BOARD ACTION REPORT – APPEALABLE ITEM

Project Name: The Ray Hotel

SITE PLAN REVIEW AND APPEARANCE BOARD

File No: 2020-054-SPM-SPR-CLIV

Enlarged Floor Plan
Rooftop LevelScale
1/16"=1'-0"

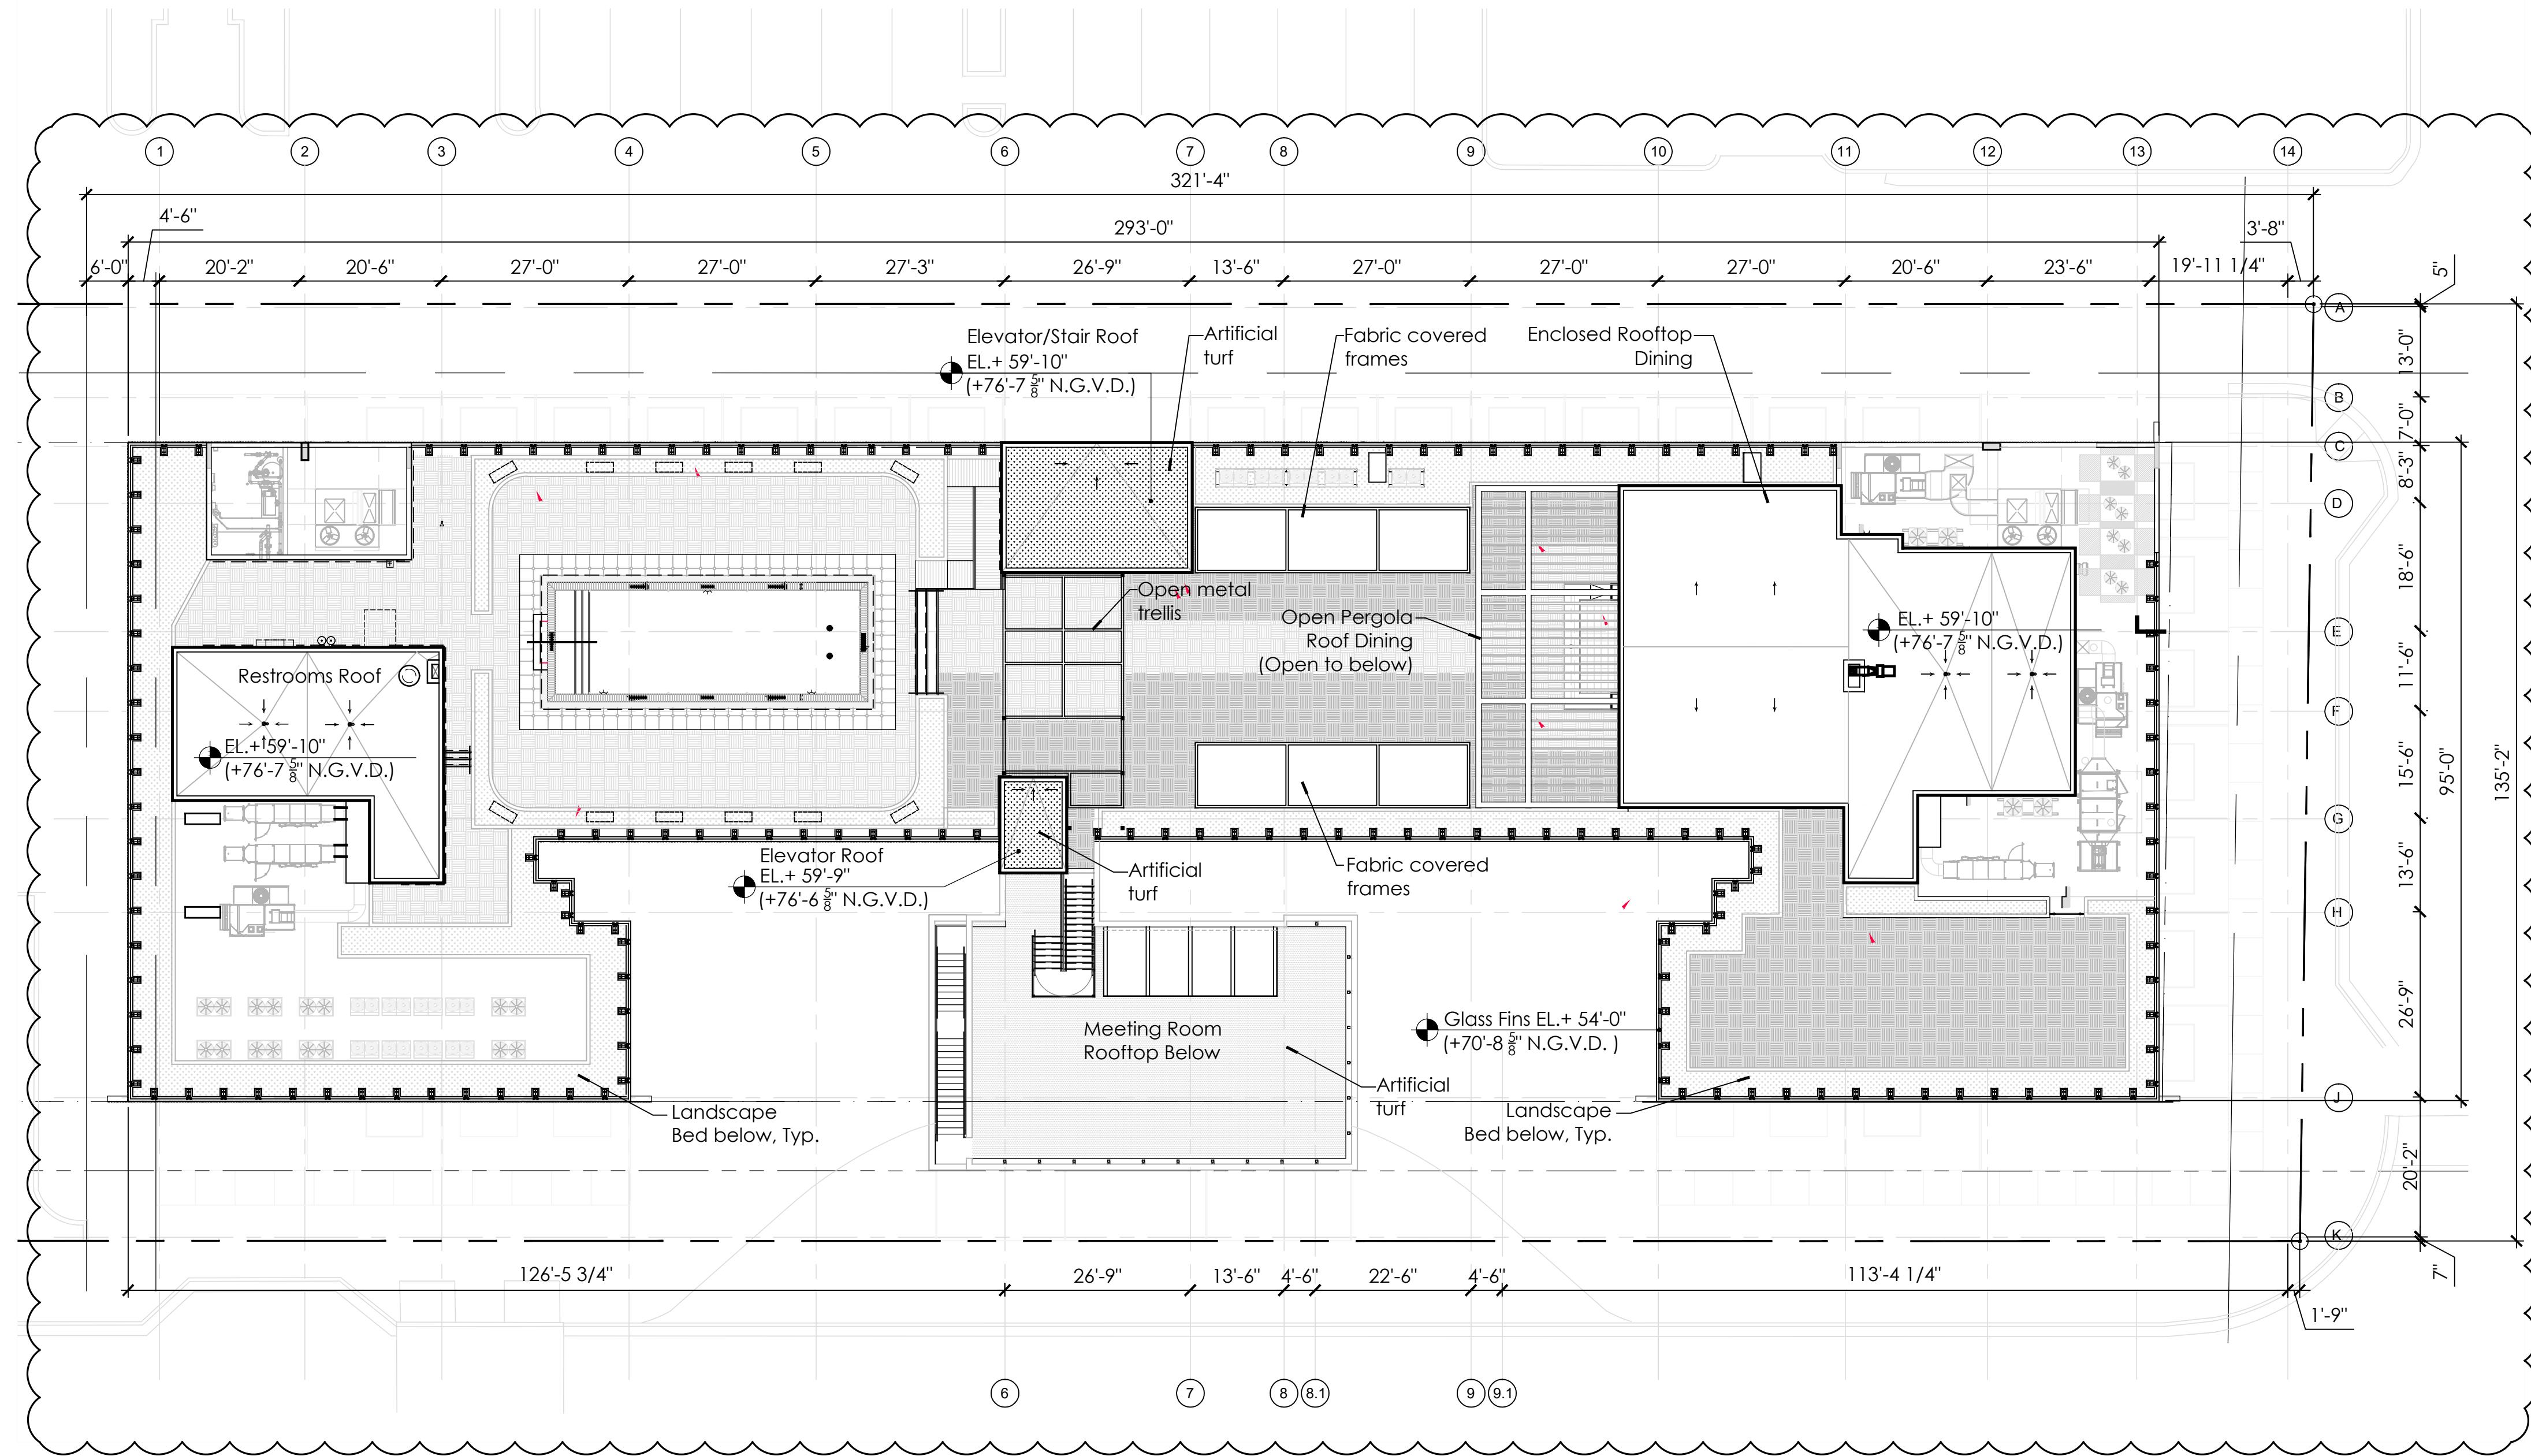
5. Update the roof top covering percentage calculations on sheet 20 to 18% prior to site plan certification.
6. Replace fixture LX-211C on the roof top light plans sheets LT-800 and LT-801 to a full cut off luminaire prior to site plan certification.
